Access Compliance Report

Public Rights-of-Way

(Curb Ramps)

Intersection ID: 29147	Main Street: BALSAM_TREE_DR	Cross Street: WALLACE_RIDGE_DR	Location: SW
ADA ID: E6B78EC809C2	Ramp Type: PerpDiag	Initial Pass/Fail: Fail	Overall Compliance: No
Severity Score: 10			
Codes/Mitigation Info/Possible Solution		Field Measurements/Component Compliance

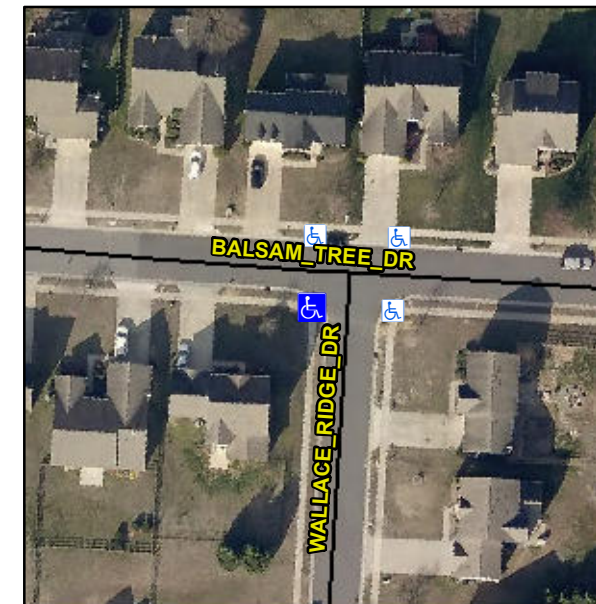
Not Found, R304.5.1, R304.5.3

Compliance	Description	Data	Compliance	Description	Data
N/A	Ramp Length (in)	64.0	Yes	Ramp Slope (%)	5.5
No	Ramp Width (in)	44.0	No	Ramp XSlope (%)	3.7
N/A	Flare Type LT	N/A	N/A	Flare Type RT	N/A
N/A	Flare Slope LT (%)	N/A	N/A	Flare Slope RT (%)	N/A
N/A	Flare Traversable LT?	N/A	N/A	Flare Traversable RT?	N/A
N/A	Landing Length (in)	N/A	N/A	DWS Provided?	N/A
N/A	Landing Width (in)	N/A	N/A	DWS Contrast?	N/A
N/A	Landing Slope (%)	N/A	N/A	DWS Length (in)	N/A
N/A	Landing X Slope (%)	N/A	N/A	DWS Full Width?	N/A
N/A	Landing Curb? (Y/N)	N/A	N/A	DWS Offset (in)	N/A
N/A	Shared Landing?	N/A			
N/A	Gutter Ponding?	N/A	N/A	Gutter Slope (%)	N/A
N/A	Gutter Lip Ht (in)	N/A	N/A	Gutter X Slope (%)	N/A
N/A	Painted X Walk1?	No	N/A	Painted X Walk2?	No
	X Walk 1 Direction	To N		X Walk 2 Direction	To E
N/A	X Walk 1 Width (in)	N/A	N/A	X Walk 2 Width (in)	N/A
	X Walk 1 Slope (%)	5.3		X Walk 2 Slope (%)	0.9
	X Walk 1 X Slope (%)	2.1		X Walk 2 X Slope (%)	3.3

N/A	Ramp inside XWalk1?	N/A	N/A	Ramp inside XWalk2?	N/A
	Road Slope (%)	4.1	N/A	Clear Space?	N/A
	Road X Slope (%)	0.4	N/A	Clear Space to XWalk (in)	N/A
N/A	Any Obstructions?	N/A	N/A	Storm Grate/Utility Hazard?	N/A
	Obstruction Type			Storm Grate/Utility Type	
		N/A			N/A
		Yes		Surface Condition? (G/P)	Good

Remove & Replace Curb Ramp With Two New Directional Ramps or Equivalent.
